## DRAINAGE AND TRANSPORTATION INFORMATION SHEET (REV 6/2018)

**RE: DUTCH BROTHERS COFFEE  
3615 NM 528  
TRAFFIC CIRCULATION LAYOUT**

Re: **Dutch Brothers Coffee**  
**3615 NM 528**  
**Traffic Circulation Layout**  
Architect's Stamp date 2/09/2021 (A14D019)  
Via email lnoriega@tierrawestllc.com

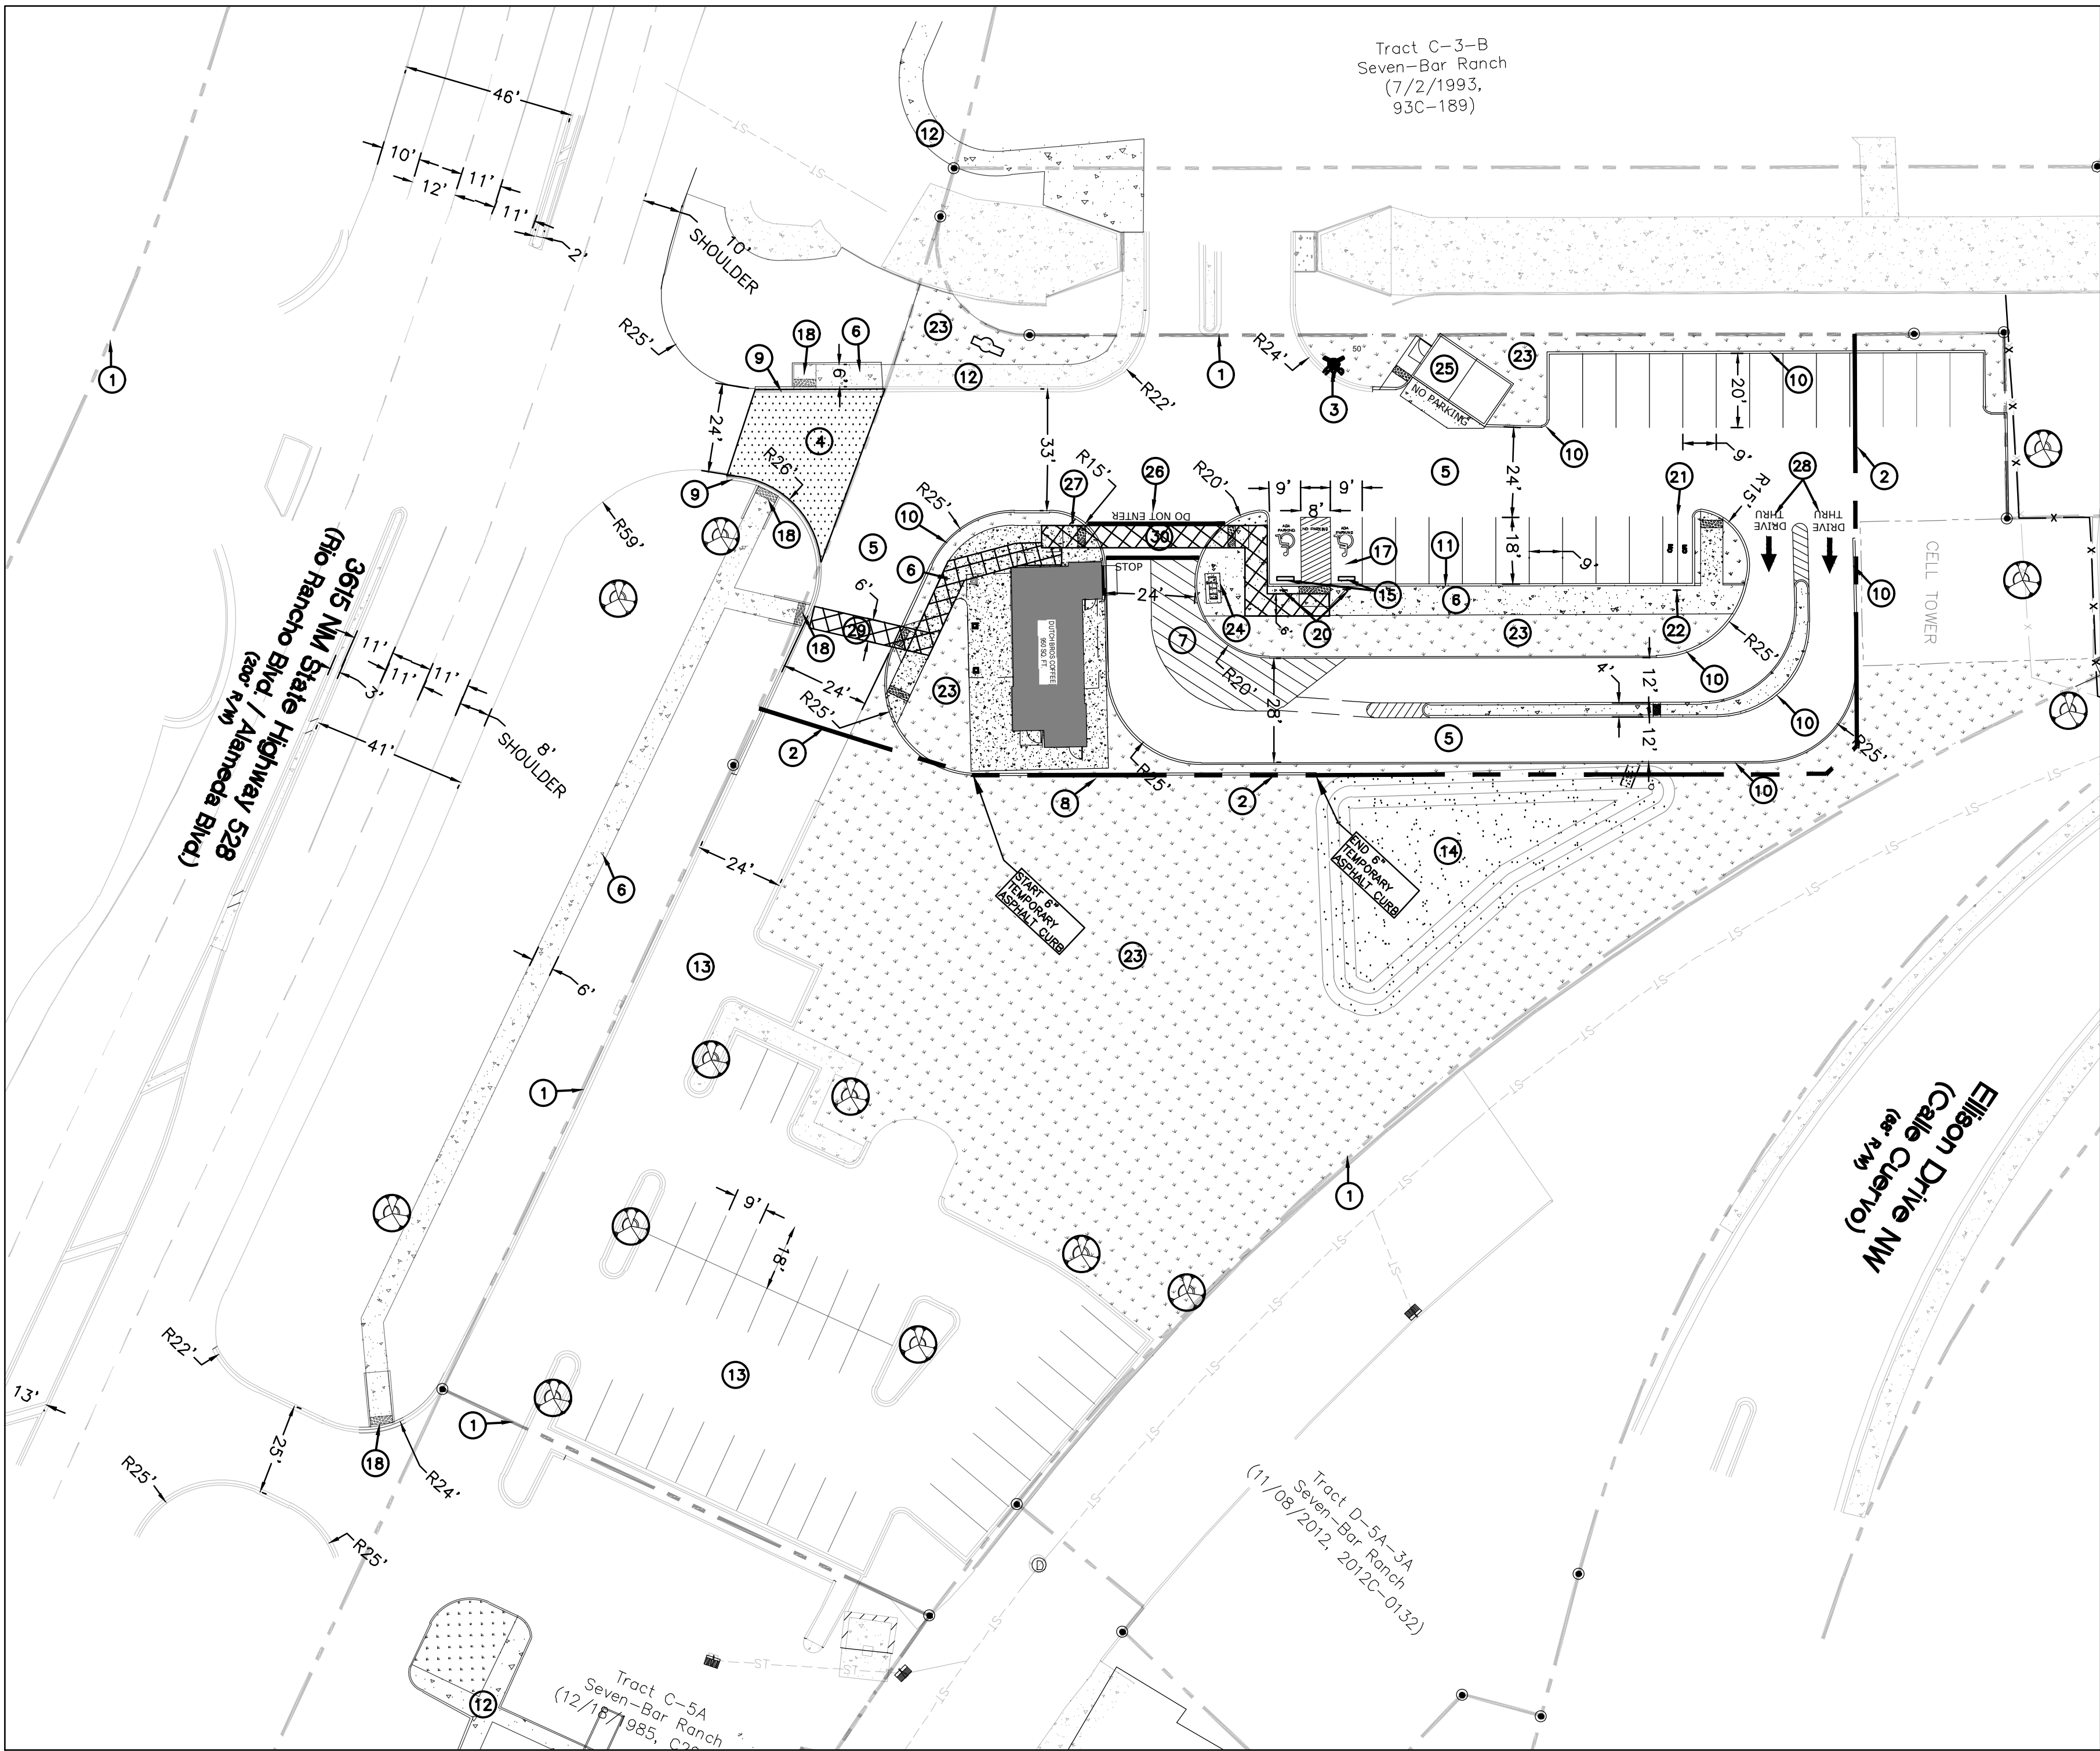
1. Provide a Traffic Scoping Form or approved Traffic Impact Study for the development.
2. Provide shared access agreement for the adjacent property and share use agreement for the driveway on NM 528.
3. Fire and emergency access: Provision for access by fire and emergency vehicles needs to be in accordance with the Albuquerque Fire Plan Checking Division. Provide approval from the Fire Marshall.
4. Suggested sidewalk and ramp alignment on attached drawing.
